TITLE: **CHANGE OF ZONE NO. 07060A,** an amendment to the **Wilderness Heights Planned Unit Development**, requested by West Dodge Place, on property generally located at the southeast corner of South 40th Street and Yankee Hill Road.

PROJECT #: Change of Zone No. 07060A (PUD)

PROPOSAL: This application will allow Motorized Vehicle Sales and Service as an allowed use in the Planned Unit Development (PUD) and revises the site plan to accommodate this use. This application also changes the underlying zoning on a piece of ground east of the drainage way from B-2 Planned Neighborhood Business to R-3 Residential and removes it from the PUD.

SHEET
1 of 5

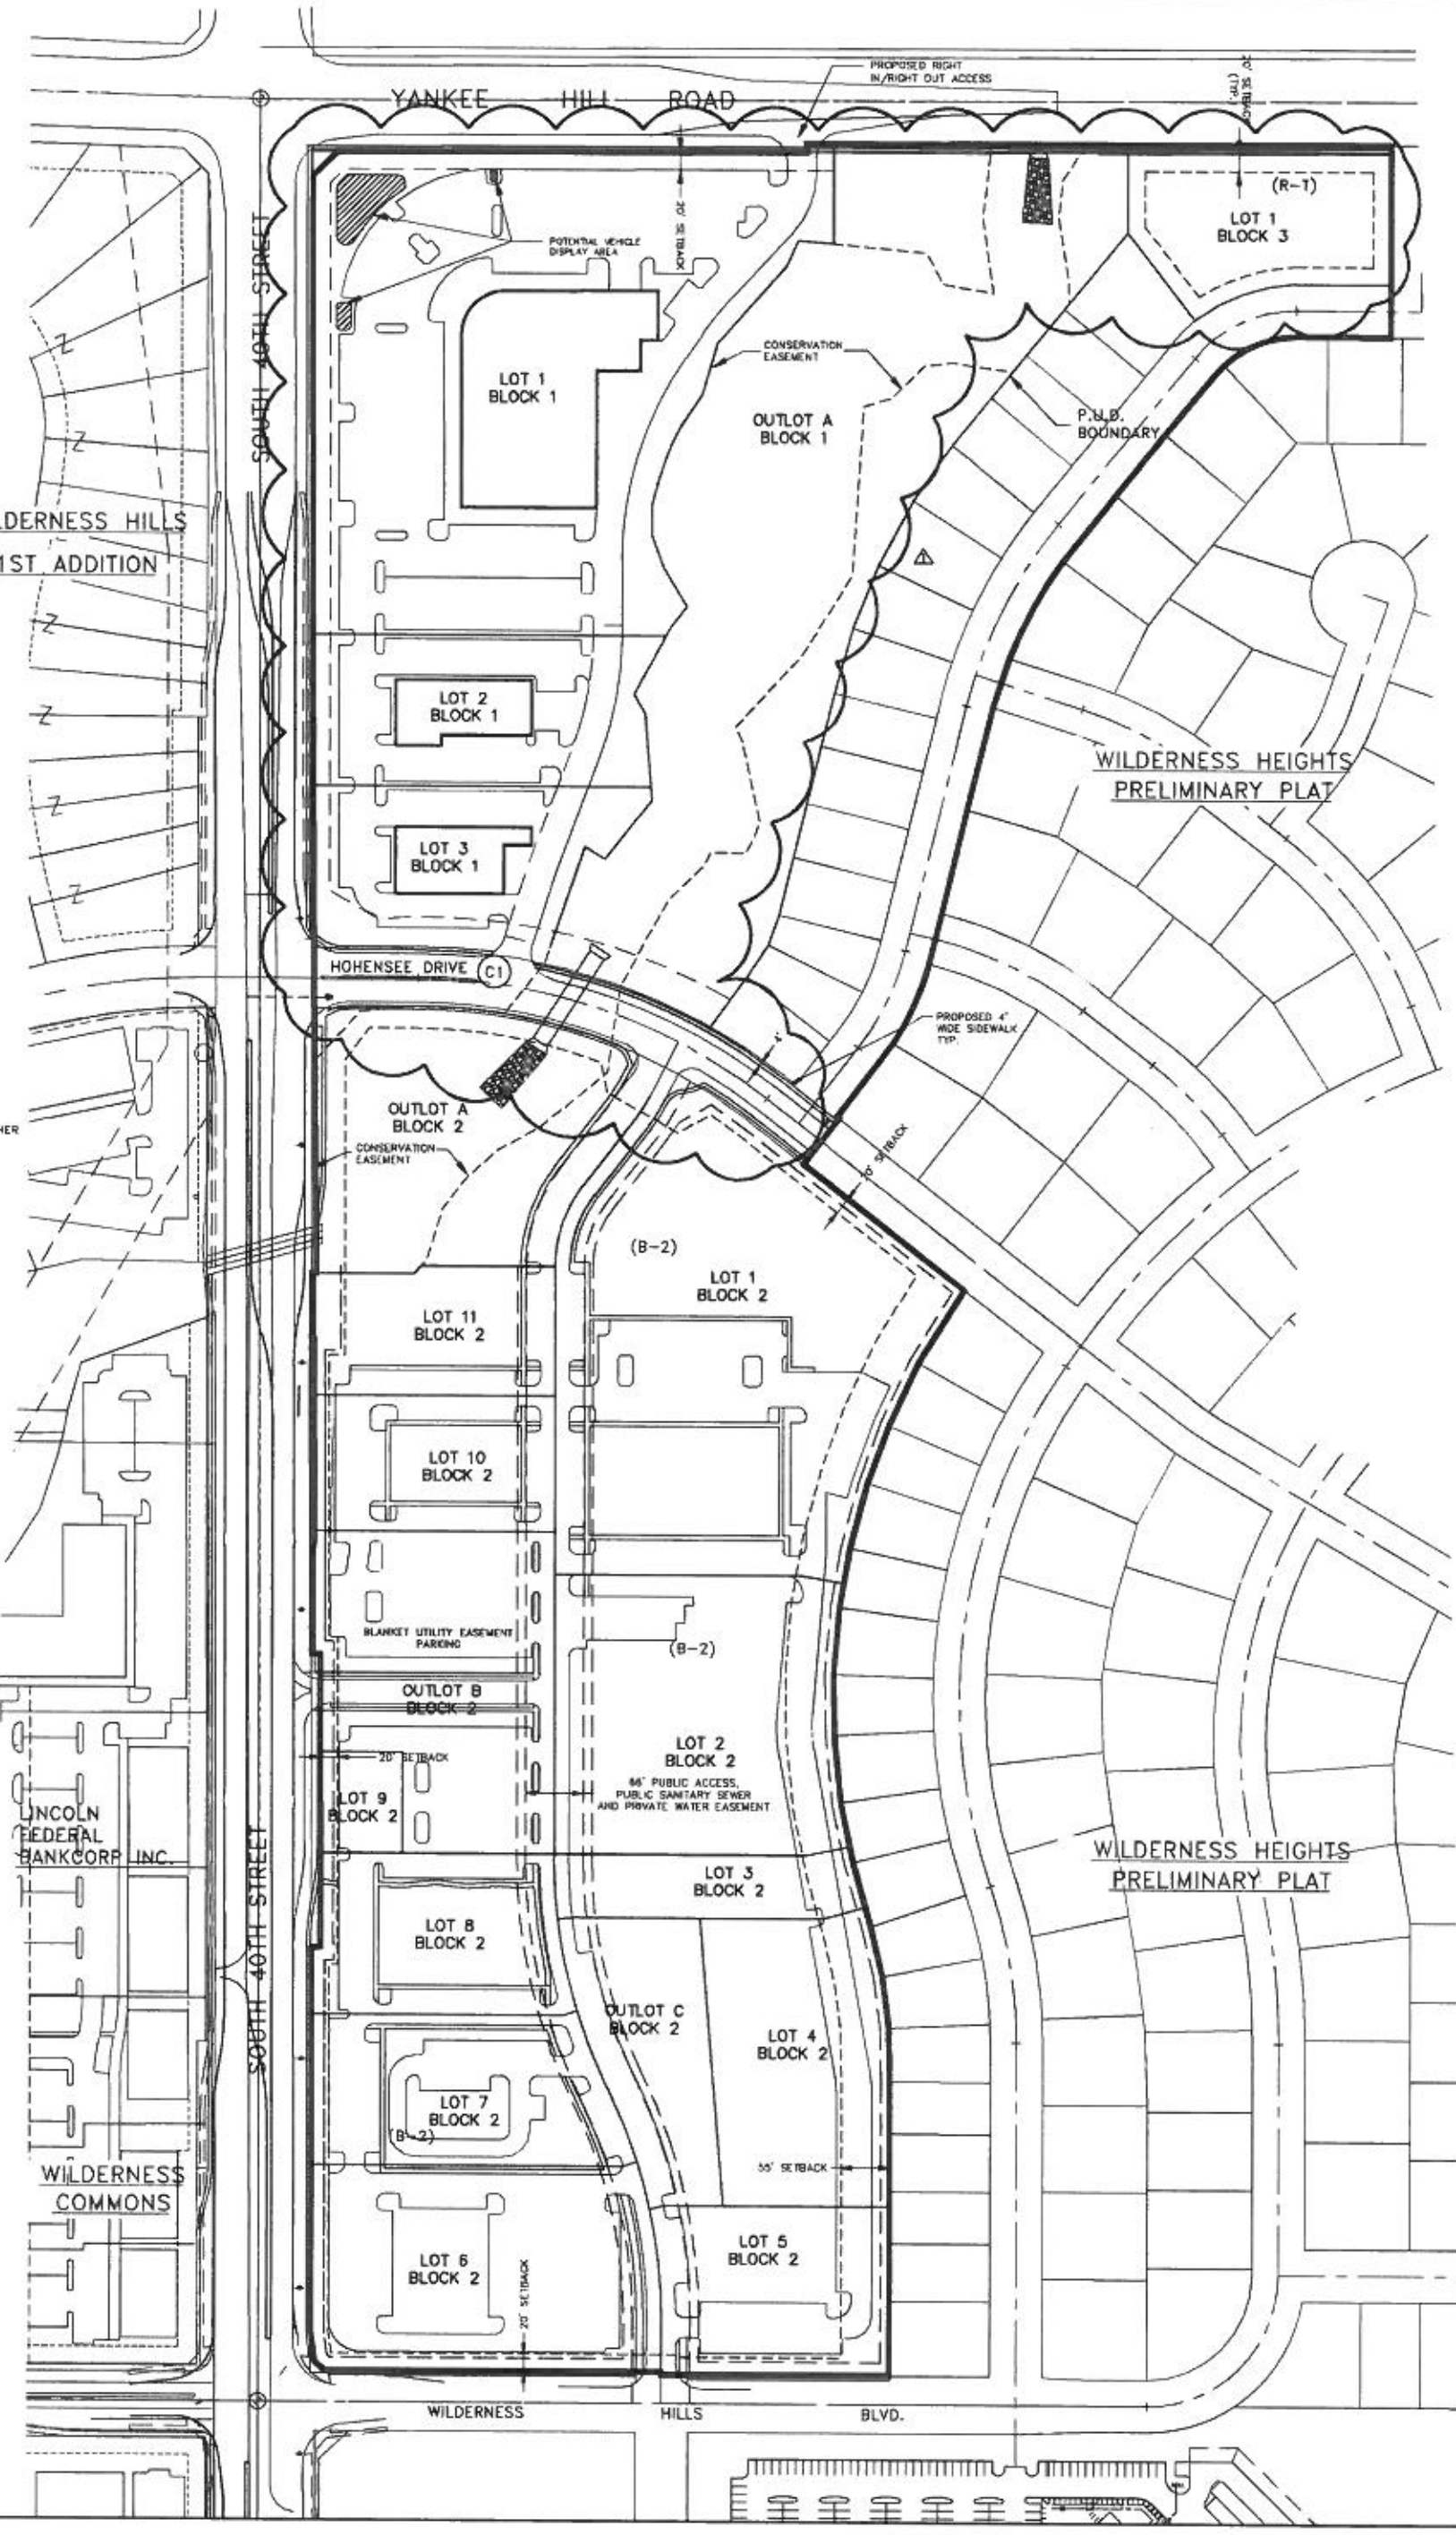
2.3 Sheet 1 of 5: A Conservation Easement has been approved (instrument # 2008048213). Revise notes accordingly (e.g. notes 7, 8, 9, etc).

2.4 Sheet 1 of 5, note 8: revise to the following or similar: Development shall be restricted by the conservation easement per the terms and conditions of the Conservation Easement. Development shall also be restricted by New Growth Area

Standards per the City floodplain standards. {Note there is no longer a floodprone area anymore as this corridore has been adopted by FEMA as a floodplain area}

2.5 Sheet 1 of 5, Note 9: Add to the last sentence that there will be no utilities installed without prior approval by the Public Works and Utilties Director per the Conservation Easement.

2.6 Sheet 1 of 5: Have same line type and weight for the Conservation Easement boundary.

SHEET 2 of 5

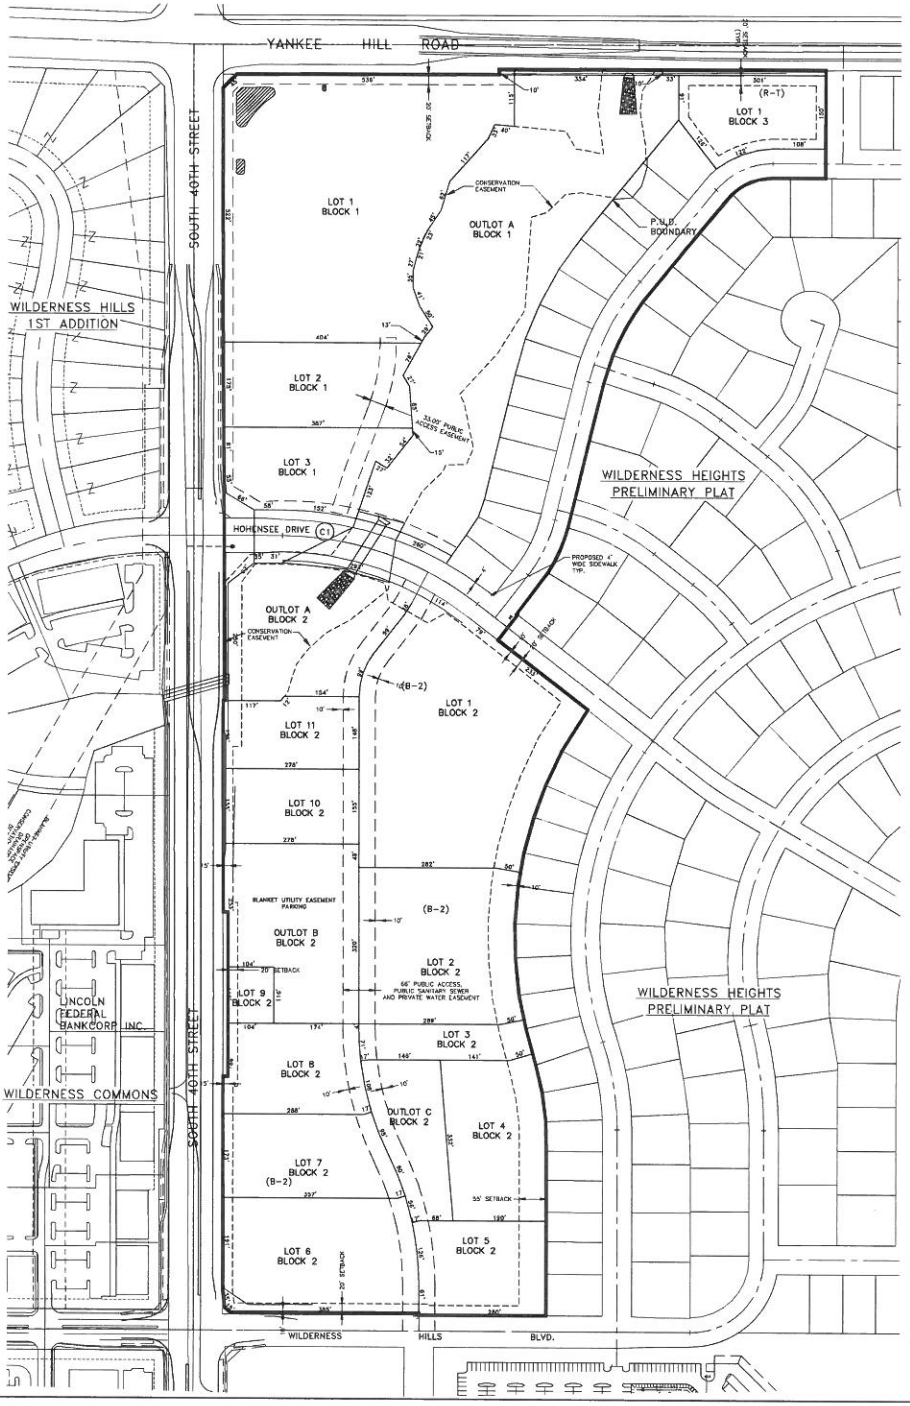
Revise the plans to show Hohensee drive paving dimensions. Also dimensions the right-of-way for Hohensee. Paving widths,lengths and lanes should match the traffic study. The street needs to be graded the full ROW width. My interpretation of the plan is that it is not shown to be graded that way in the vicinity of the box culvert crossing.

The plans need to show full grading of the Yankee Hill ROW for construction of the future urban cross section roadway. It is not clear that the lots shown, especially Lot1, Block 3 is graded to meet that requirement.

The acces to Yankee Hill Road is taking access to temporary paving. I request that the improvements needed to Yankee Road needed at this driveway be dimensioned to show the extent of construction needed. I am specifically referencing the required temporary left and right turn lanes.

40th Street is shown with full build out of the urban section paving. The extent of buildout for this project needs to be clarified and approved. I recommend the buildout that is approved be detailed on these plans.
